MIL-F-8975B
AMENDMENT 2
23 March 1994
SUPERSEDING
AMENDMENT 1
27 May 1988

MILITARY SPECIFICATION

FASTENER, BLIND, HIGH STRENGTH, INSTALLATION FORMED CORROSION RESISTANT STEEL, HEAT RESISTANT STEEL AND TITANIUM

This amendment forms a part of Military Specification MIL-F-8975, dated 29 September 1982, and is approved for use by all departments and agencies of the Department of Defense

FIGURE 1. Visual inspection illustration, Type I.

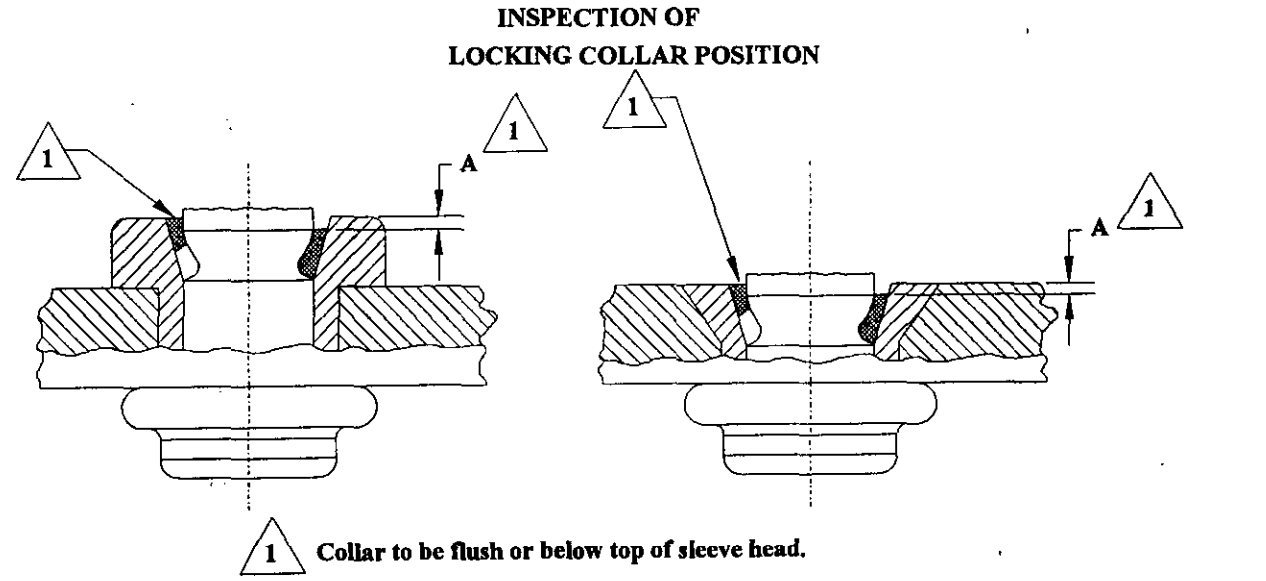
* Figure 1. Delete in its entirety and substitute:
